# ORIGINATION FORM

Index Number: **591-001**  
Sheet Number (s): 1 of 1  
Index Title: Landscape Irrigation Sleeves

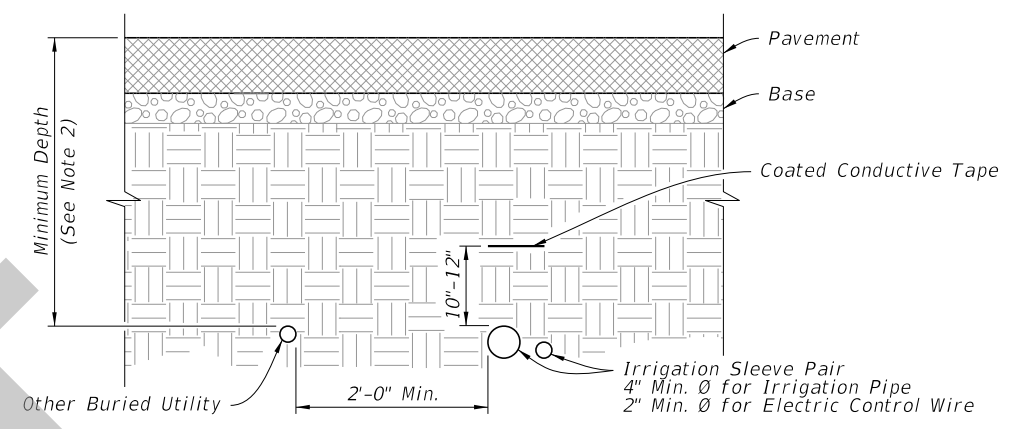
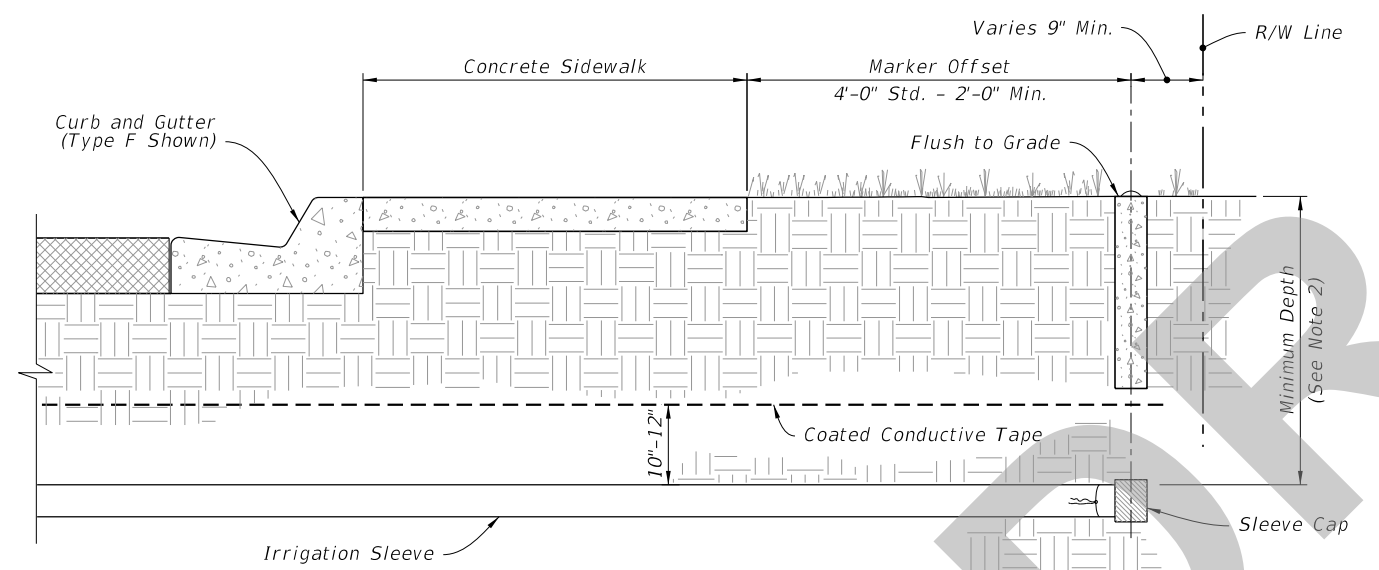
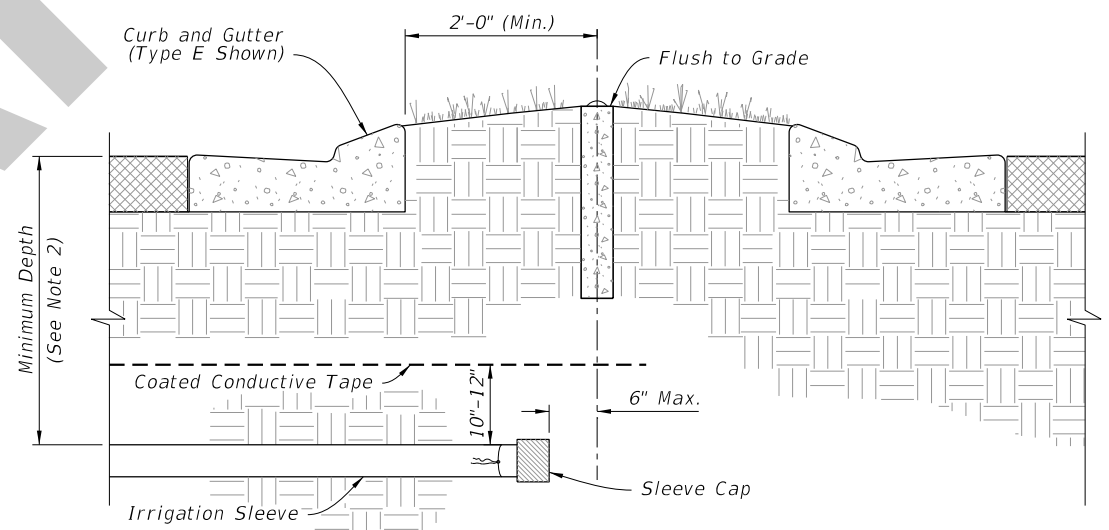
New Index.
